APPEAL SUMMARY

Appeal ID: 20258	Project Address: 909-919 SW Taylor St
Hearing Date: 4/17/19	Appellant Name: Ingrid Hoffman
Case No.: B-010	Appellant Phone: 5032133575
Appeal Type: Building	Plans Examiner/Inspector: John Cooley, Corey Stanley
Project Type: commercial	Stories: 1 Occupancy: M Construction Type: I-B
Building/Business Name: Guild Theater/Kinokuniya Bookstores of America	Fire Sprinklers: Yes -
Appeal Involves: Alteration of an existing structure, Reconsideration of appeal	LUR or Permit Application No.: 18-183386-CO
Plan Submitted Option: pdf [File 1]	Proposed use: Bookstore

APPEAL INFORMATION SHEET

EXHIBIT B

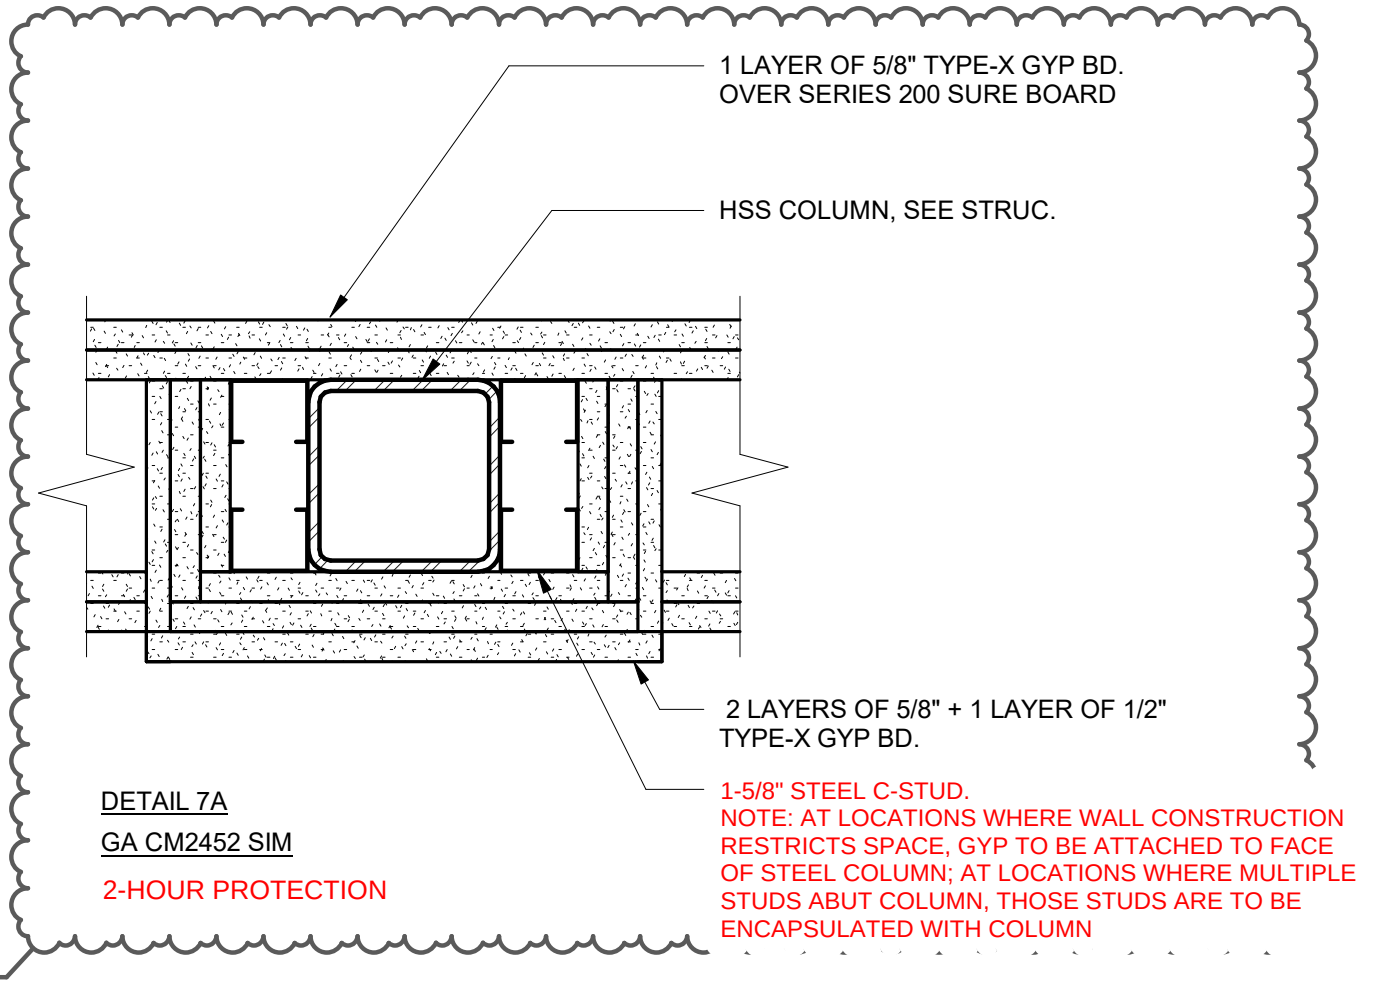
Code Section 704.2 Column Protection

Requires Where columns are required to have protection to be fire-resistance rated, the entire column shall be provided individual encasement protection by protecting it on all sides for the full column length, including connections to other structural members, with materials having the required fire-resistance rating.

Proposed Design See detail submitted as "Exhibit B".

Detail submitted is modified from assembly GA CM2452 for 2-hour protection of columns.

Reason for alternative This project is being constructed and is ready for gyp board immediately. The encapsulation of the columns was not captured in the permitted documents and was brought to attention by the building inspector. Columns are located in shear walls and a full encapsulation would disrupt the shear panel. Per an onsite meeting between the contractor, architect, structural engineer, plans examiner, and building inspector (as well as additional communication with the plans examiner) the submitted detail is proposed for the protection of the columns within the rated walls. The columns support the mezzanine floor only. The GA assembly calls for a 1-3/4" thickness which we are providing on three sides, and on the shear wall side we are providing 1-1/4" thickness plus a layer of metal protection. See submitted "Exhibit C" for documentation that references the fire-resistance of the series 200 Sure Board as better than standard gyp board due to the addition of metal protection.

2. Alternate 2 hour beam encasement: Granted as proposed.

UL N501 2-HOUR PROTECTION FOR BEAMS

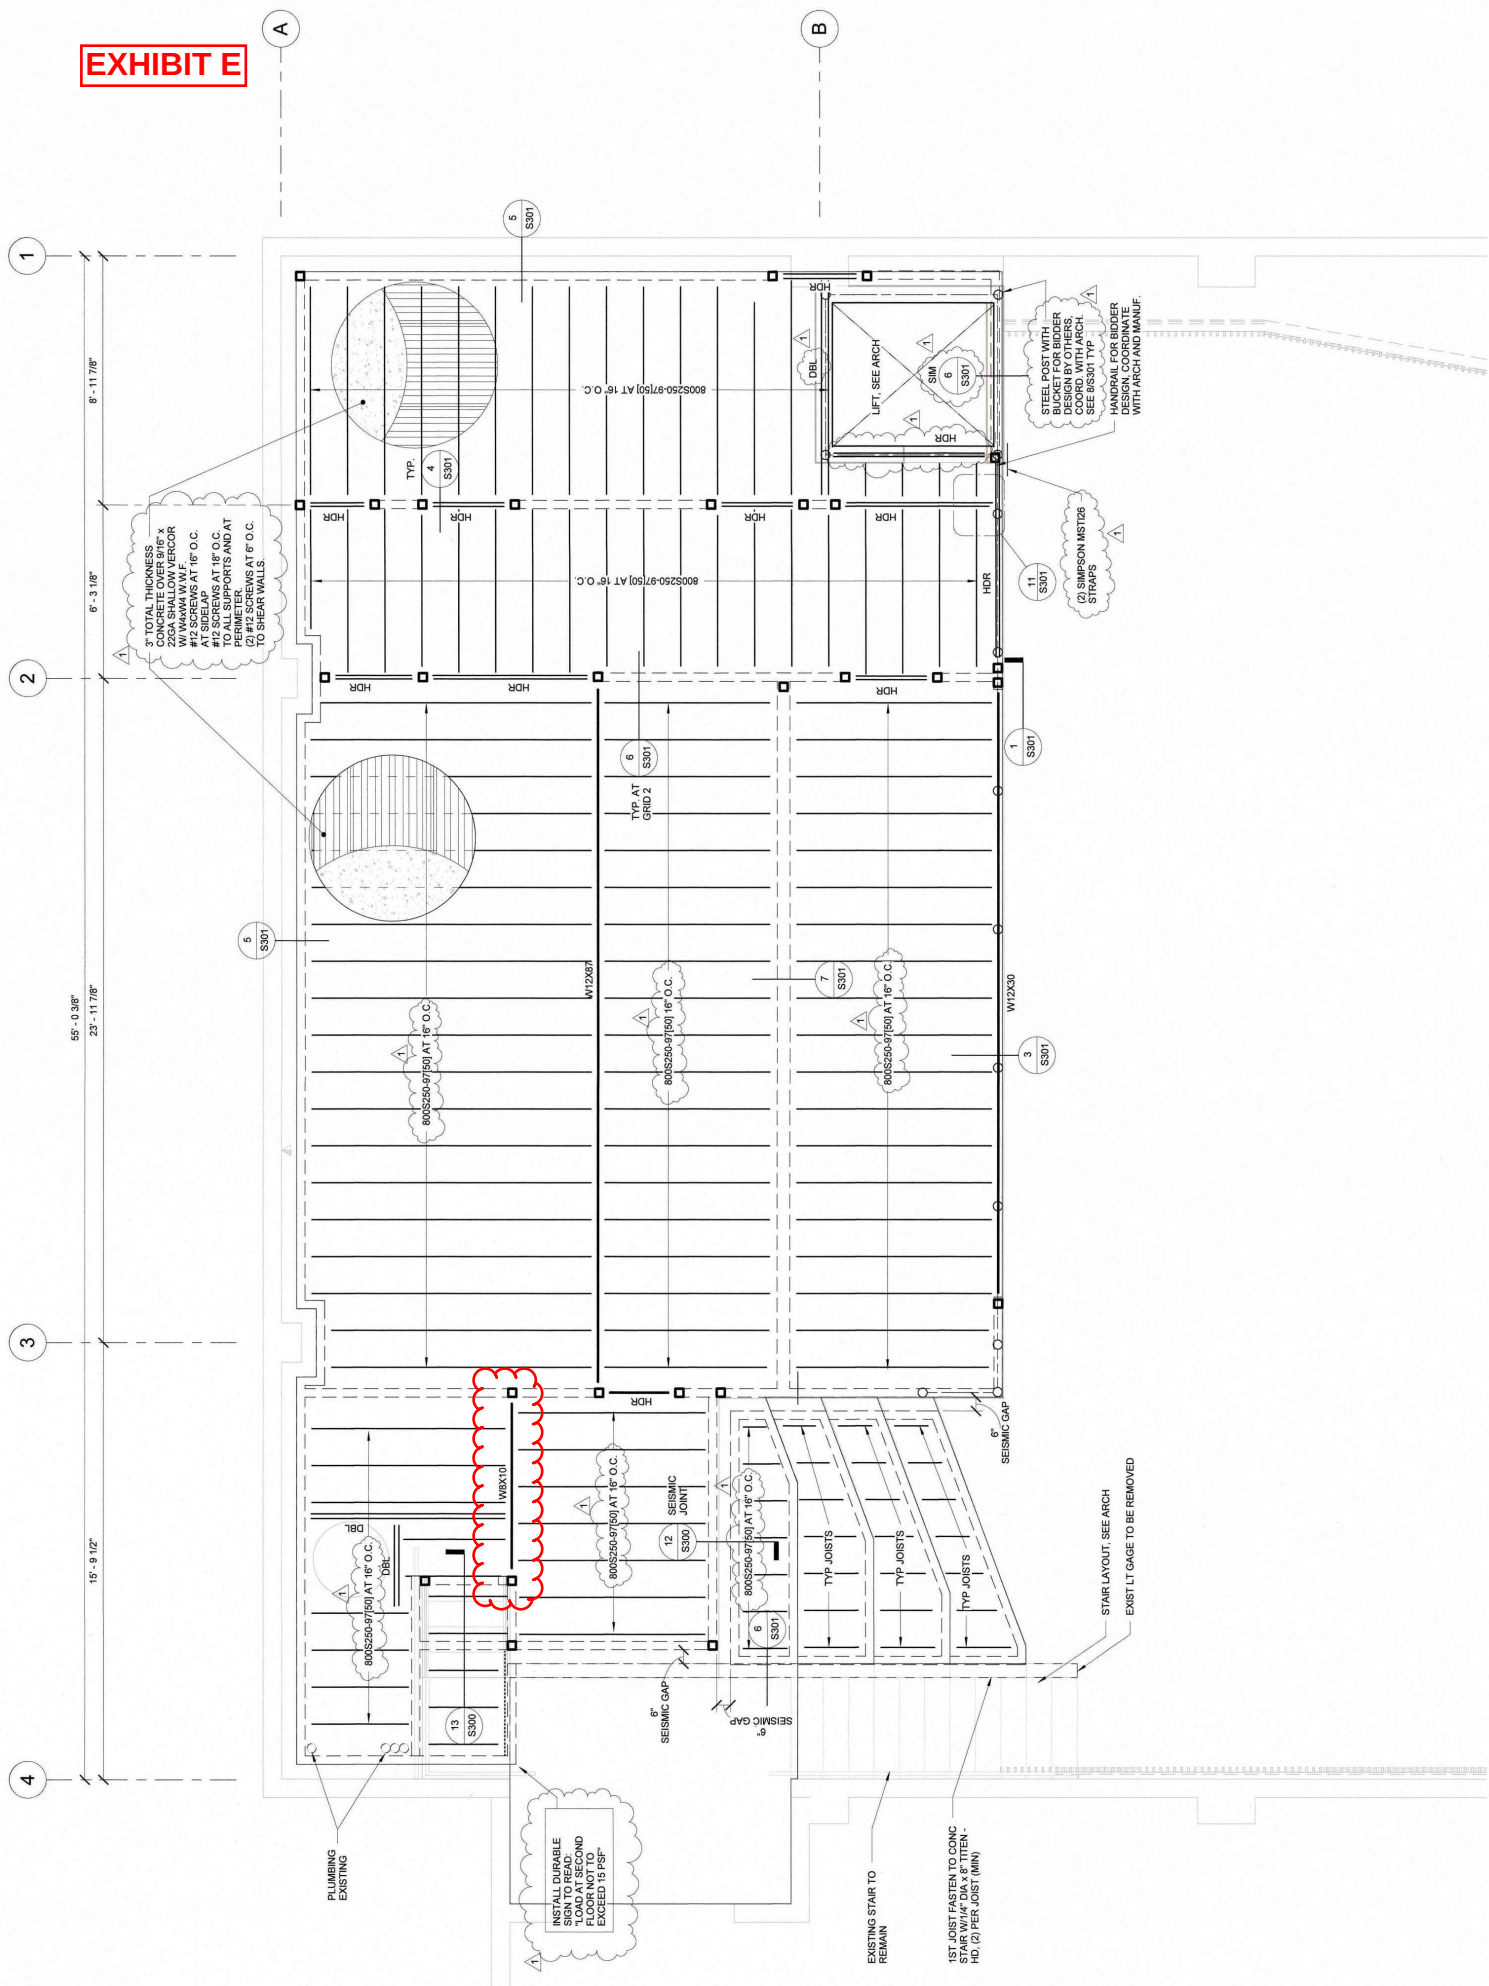
Code Section UL N501

Requires Encasement of beams below the floor assembly.

Proposed Design See submitted "Exhibit D"

Detail submitted is modified from assembly UL N501 for 2-hour protection of beams.

Reason for alternative A modification of the UL N501 design is proposed to encase beams in the floor assembly of the mezzanine. This encasement is per the GA Fire resistance manual for beams that project more than 6" below the plane of the ceiling. Beams are not subject to OSSC section 704.3 as they support only one floor. There is one beam that is W8x10 and this size beam is not addressed by

any UL assembly. We propose adding one additional layer of Type C gyp board to encase the W8x10 beam. This particular beam has a very limited tributary area (see "Exhibit E" structural plan view) and we believe the additional layer of gyp bd compensates for the smaller beam size. Beams ends will be captured within 2-hour column and wall assemblies.

3. Alternate 2 hour UL beam assembly: Granted as proposed.
